## **Sunman-Dearborn Community Schools – BP#3**

### **ADDENDUM #2**

**ADDENDUM NO. TWO**

**PROJECT:** Sunman-Dearborn Community Schools  
**ECHS RESTROOM/CONCESSION**

# Alternate 3 Site Images

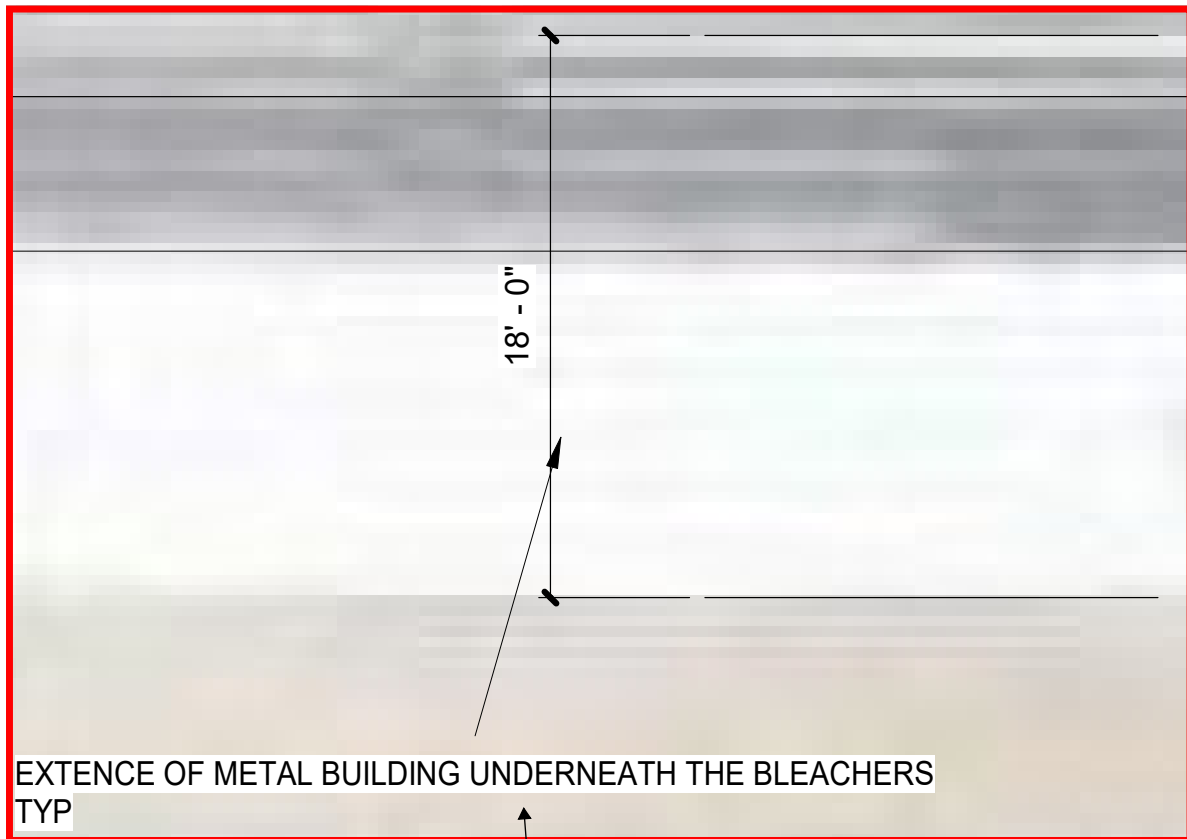
To Demo metal siding,  
wooden framing, garage  
doors, man doors, etc.

# Sheet A102 in Lancer Narrative

Please disregard this note  
on Lancer Narrative.  
Existence of metal building  
underneath bleachers is 12'.

FLOOR PLAN -  
FIRST FLOOR -  
BLEACHERS

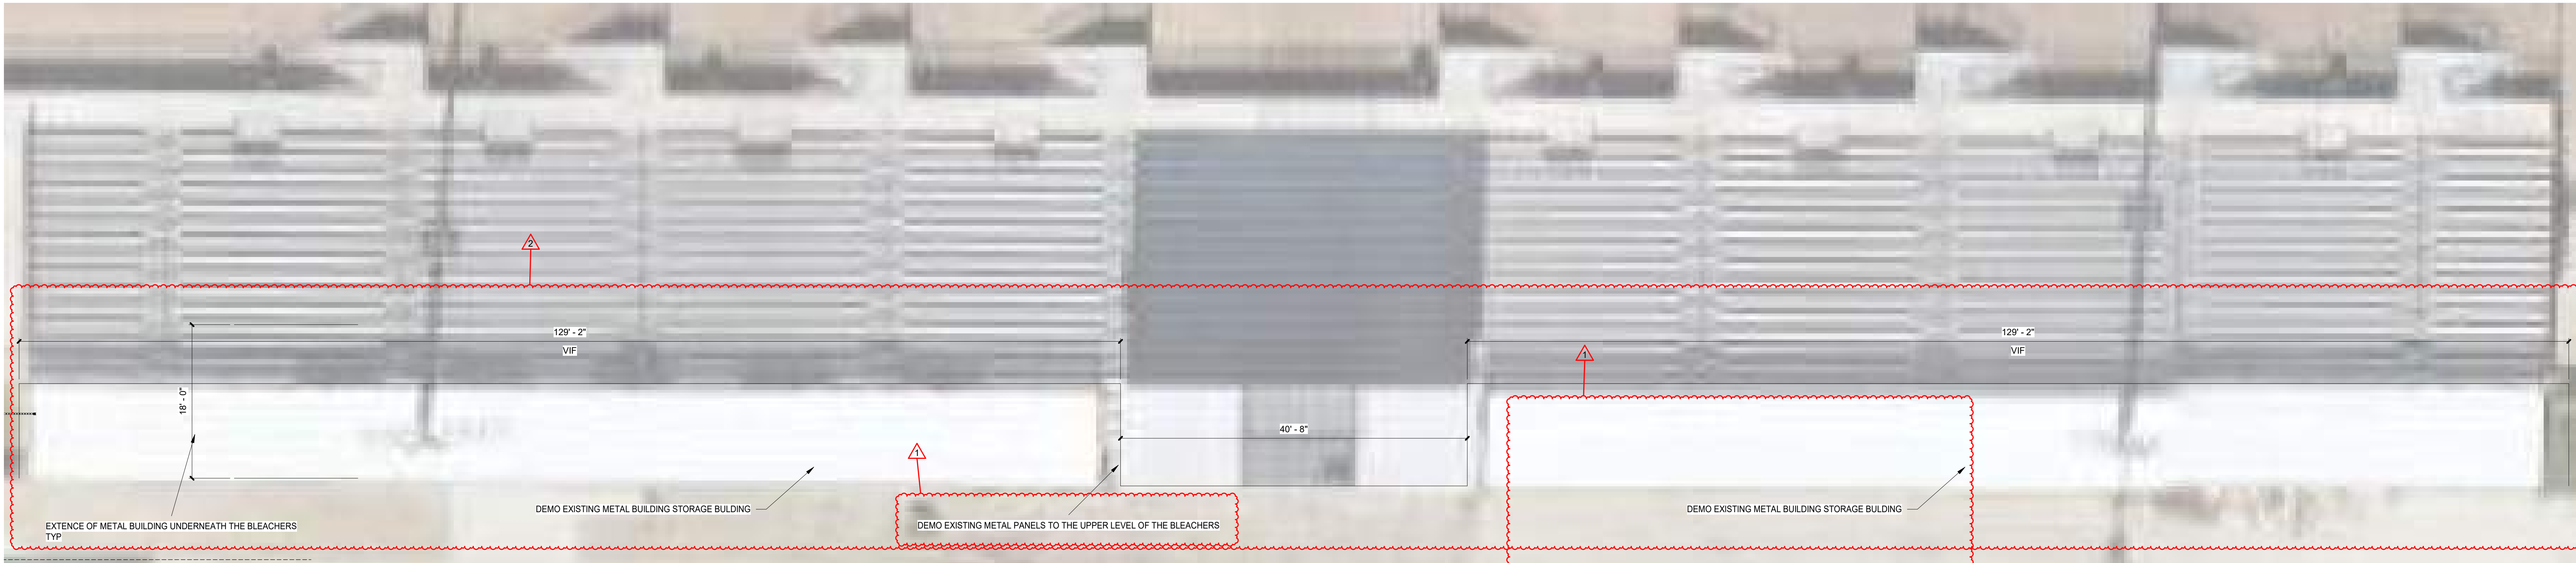
1. Drawing Sheet Number: A102  
Drawing Sheet Title: FLOOR PLAN – FIRST FLOOR - BLEACHERS
  - a. Updated dimensions, removed reference about vinyl graphics. See attached
2. Drawing Sheet E301
  - A. Revised and addition of illuminated letters. Refer to supplemental information drawing E301 for additional information.
3. Drawing Sheet E401
  - A. Updated Detail #11. Refer to supplemental information drawing E401 for additional information.
4. Drawing Sheet E501
  - A: Updated Panel Schedules; Refer to supplemental information drawing E301 for additional information.

LIGHTING PLAN

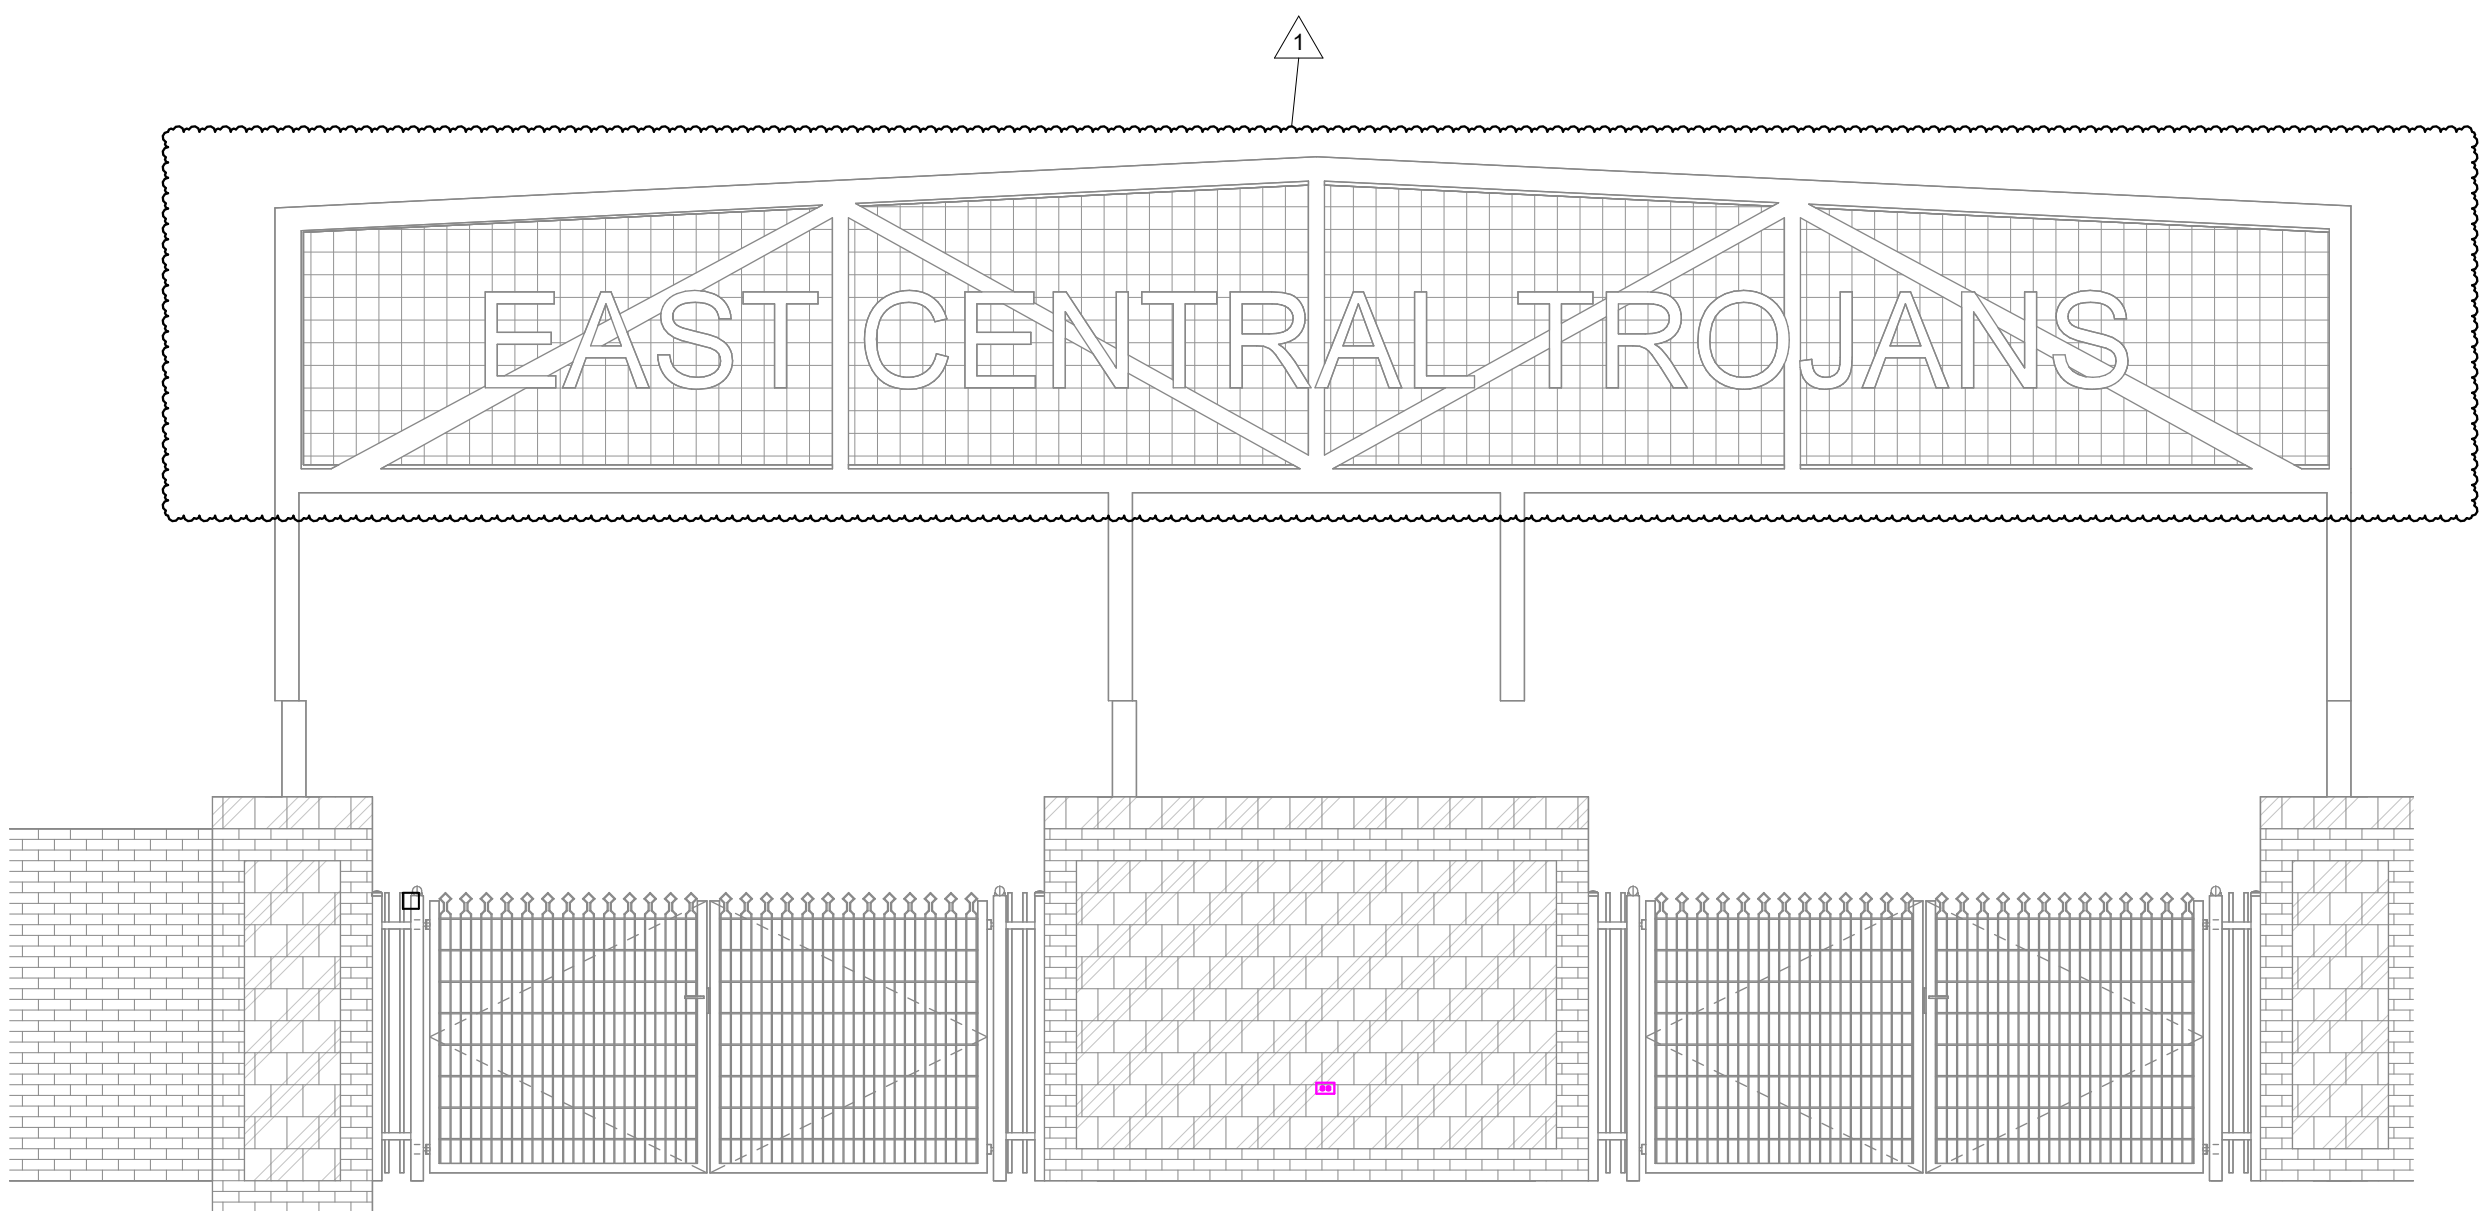
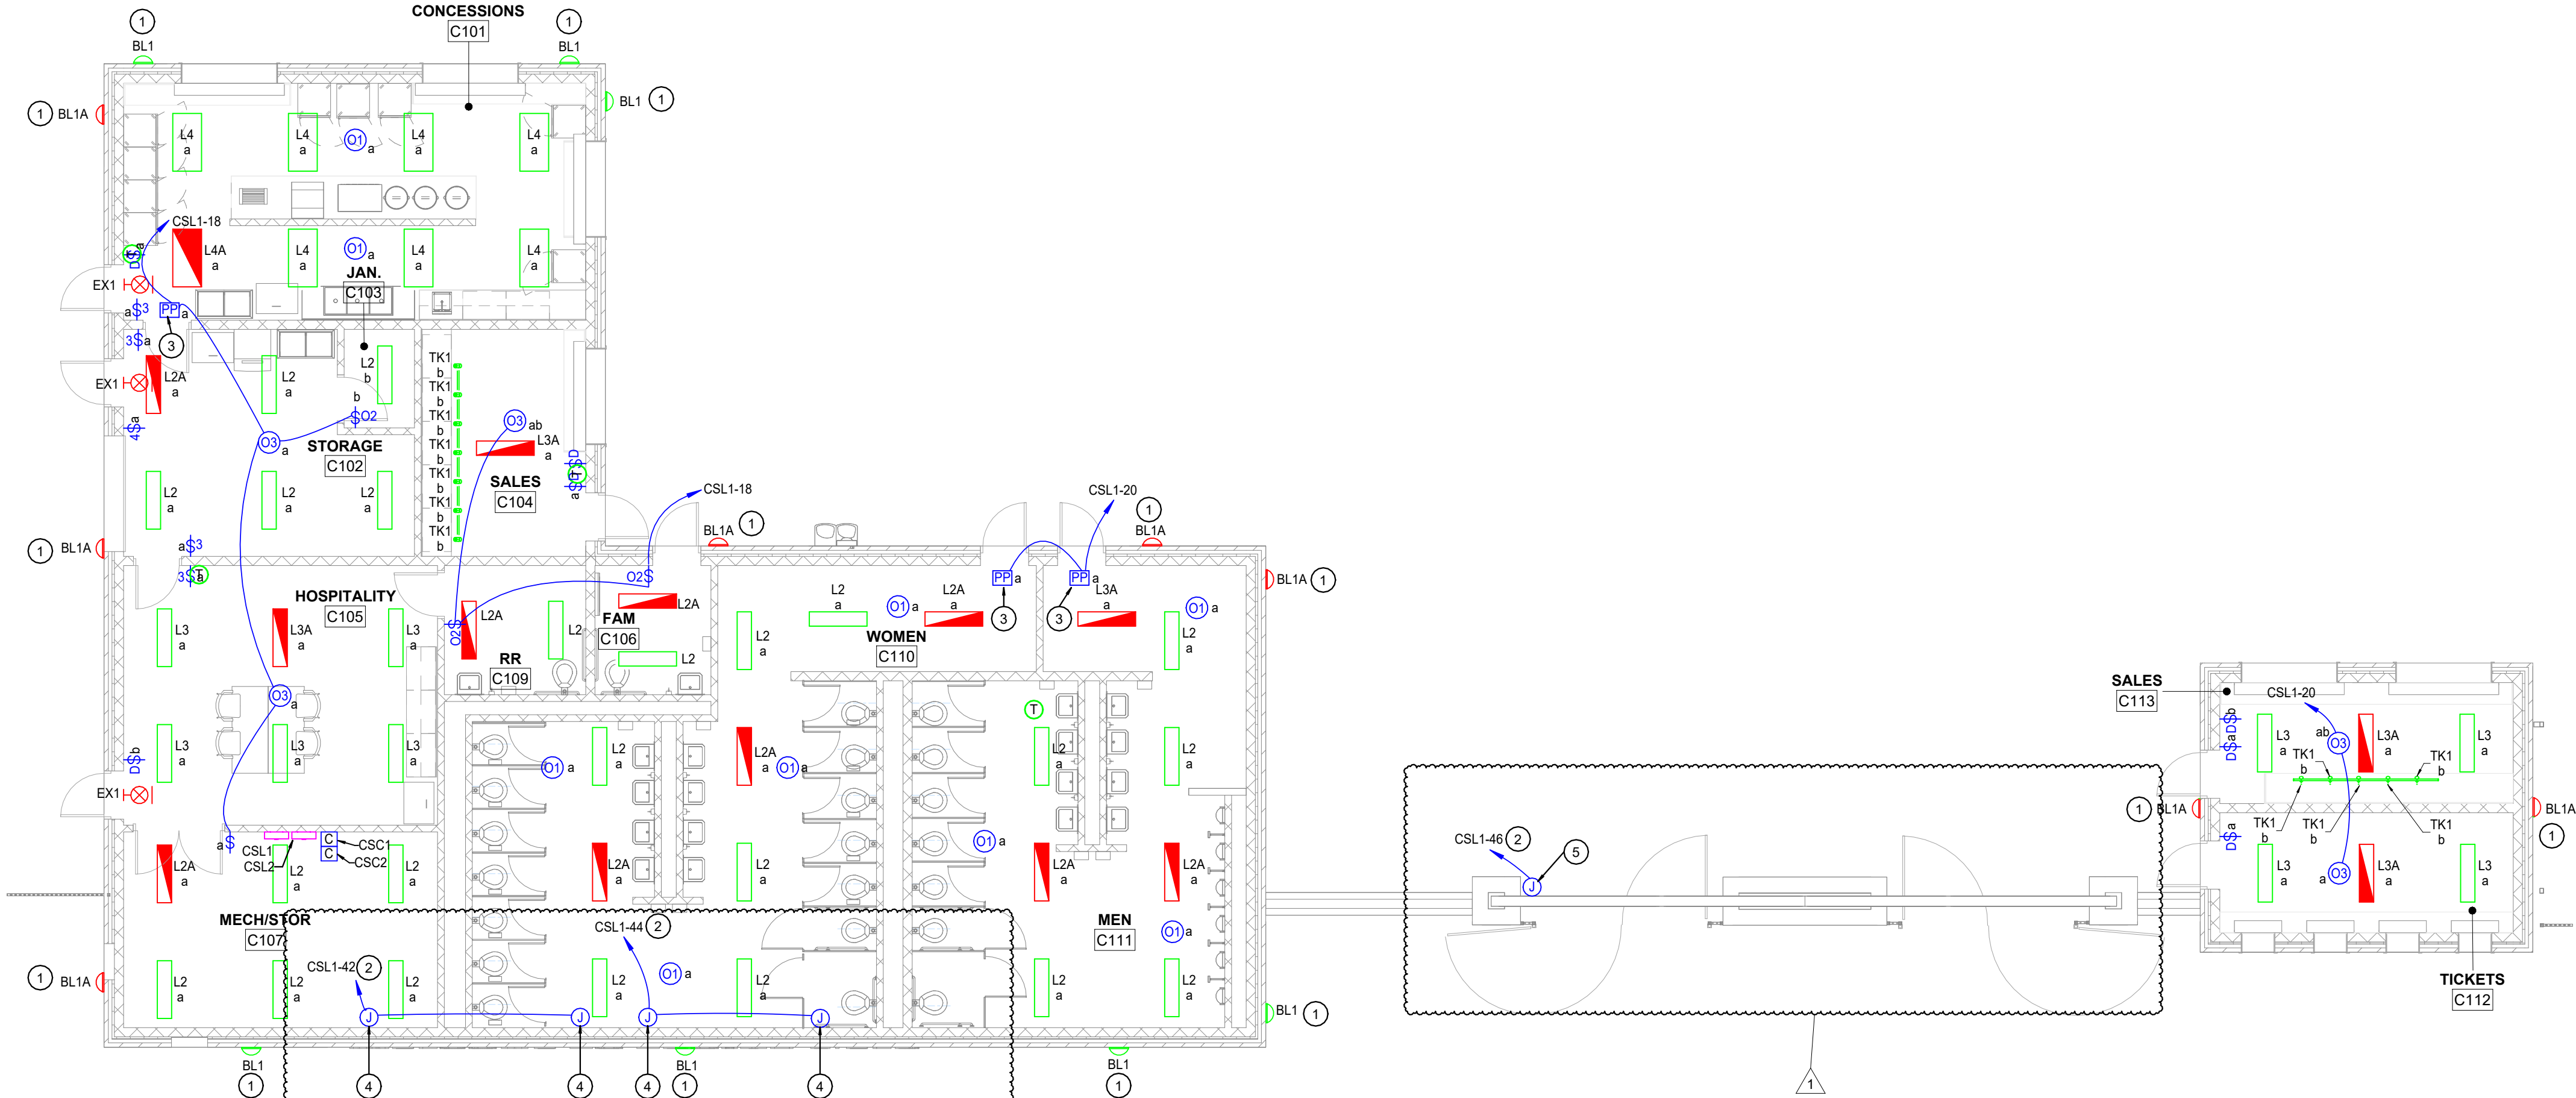
Q: No wiring to shown to feed the Backlights on E201.

A: Refer to revised drawings in Addendum #2.
